SERVICE BULLETIN

APPLICABILITY: 2012-**16MY** Impreza and XV Crosstrek Models **NUMBER:** **12-182-15R**
 2015-**16MY** WRX and STI Models **DATE:** 03-30-15
SUBJECT: New Front Door Checker Mechanism **REVISED:** **04-15-16**

PRODUCTION CHANGE INFORMATION:

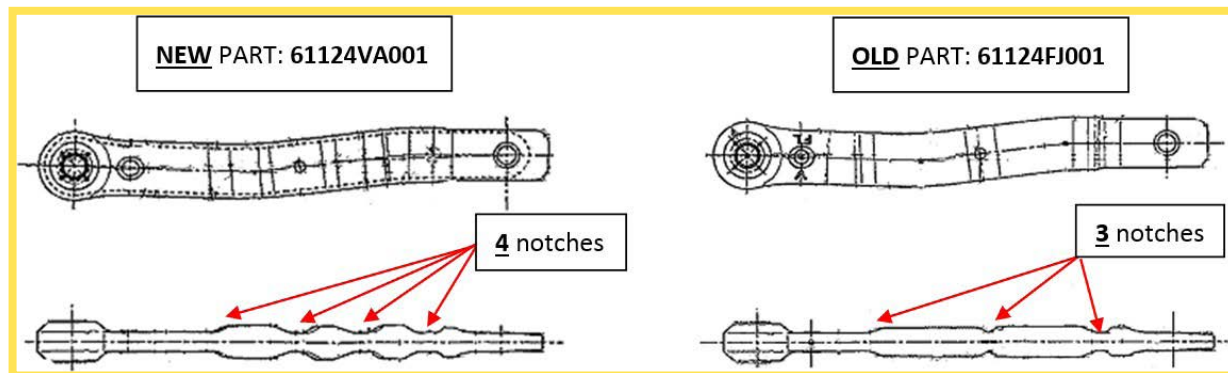
This bulletin announces availability of a new front door checker mechanism designed to hold the doors more securely when they are in partially open / closed positions. An additional detent position has also been added.

The new door checker assemblies were incorporated into production starting with the following VINs:

DESCRIPTION	NEW PART NUMBER	OLD PART NUMBERS
CHECKER ASSY DR F	61124VA001	61124FJ001 and 61124VA000
